UNITED STATES PATENT AND TRADEMARK OFFICE

APPLICATION NO.	FILING DATE	FIRST NAMED INVENTOR	ATTORNEY DOCKET NO.	CONFIRMATION NO.
10/036,064	10/19/2001	Richard H. Norris	Norris 11	3888

Office Action Summary

DETAILED ACTION

CABLE END CAPS

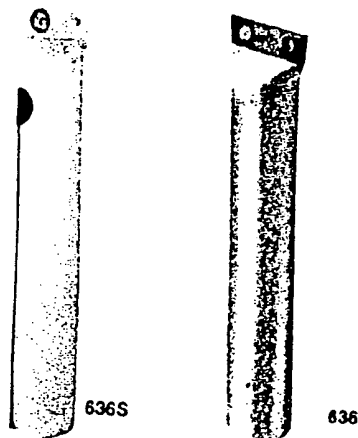
6. Claims 1, 4, 6-9, 13, 17, 19 and 20 and 22 are rejected under 35 U.S.C. 102(b) as being anticipated by Siebe inc/Salisbury (W H) and Co (cited in IDS).

Siebe inc/Salisbury (W H) and Co discloses a transmission medium, an outer jacket, disposed about the transmission medium and an end cap swaged on the end of the transmission cable, a ring (see marked figure attached), immovable, seals, shape.
